## **Access Compliance Report Public Rights-of-Way** (Curb Ramps)

Intersection ID: 7623 Main Street: DERRYDOWNE DR **Cross Street: MONTEITH DR** Location: NW ADA ID: 78BF4FFB9BE Ramp Type: BlendTrans1 Initial Pass/Fail: Fail **Overall Compliance: No Severity Score:** 1.25

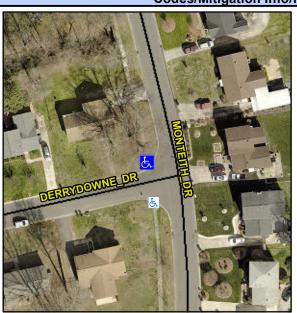
Possible Solutions: **Remove & Replace Curb Ramp With Two New Directional Ramps or** Equivalent. Surveyor Notes: N/A PROW/ADA: Not Found, R304.5.3

Field Measurements/Component Compliance					
Compliance Description		Data	Compliance Description		Data
N/A	Ramp Length (in)	39.5	Yes	BlendTrans Slope (%)	1.7
Yes	Ramp Width (in)	48.0	No	BlendTrans XSlope (%)	4.0
N/A	Flare Type LT	Sloped	N/A	Flare Type RT	Sloped
N/A	Flare Slope LT (%)	3.0	N/A	Flare Slope RT (%)	0.2
N/A	Flare Traversable LT?	No	N/A	Flare Traversable RT?	N/A
N/A	Landing Length (in)	N/A	N/A	DWS Provided?	Yes
N/A	Landing Width (in)	N/A	N/A	DWS Contrast?	Yes
N/A	Landing Slope (%)	N/A	N/A	DWS Length (in)	24.5
N/A	Landing X Slope (%)	N/A	N/A	DWS Full Width?	Yes
N/A	Landing Curb? (Y/N)	No	N/A	DWS Offset (in)	0.0
N/A	Shared Landing?	No			
N/A	Gutter Ponding?	Yes	N/A	Gutter Slope (%)	0.6
N/A	Gutter Lip Ht (in)	0.3	N/A	Gutter X Slope (%)	4.3
N/A	Painted X Walk1?	No	N/A	Painted X Walk2?	N/A
	X Walk 1 Direction	To S		X Walk 2 Direction	N/A
	X Walk 1 Width (in)	N/A		X Walk 2 Width (in)	N/A
	X Walk 1 Slope (%)	7.1		X Walk 2 Slope (%)	N/A

X Walk 1 X Slope (%)	2.0		X Walk 2 X Slope (%)	N/A
N/A	Ramp inside XWalk1?	N/A	N/A	Ramp inside XWalk2?	N/A
	Road Slope (%)	2.0		Clear Space?	Yes
	Road X Slope (%)	7.1	N/A	Clear Space to XWalk (in)	N/A
N/A	Any Obstructions?	No	N/A	Storm Grate/Utility Hazard?	No
	Obstruction Type			Storm Grate/Utility Type	
		N/A			N/A
			Yes	Surface Condition? (G/P)	Good
			No	Curb Slope (%)	18.5
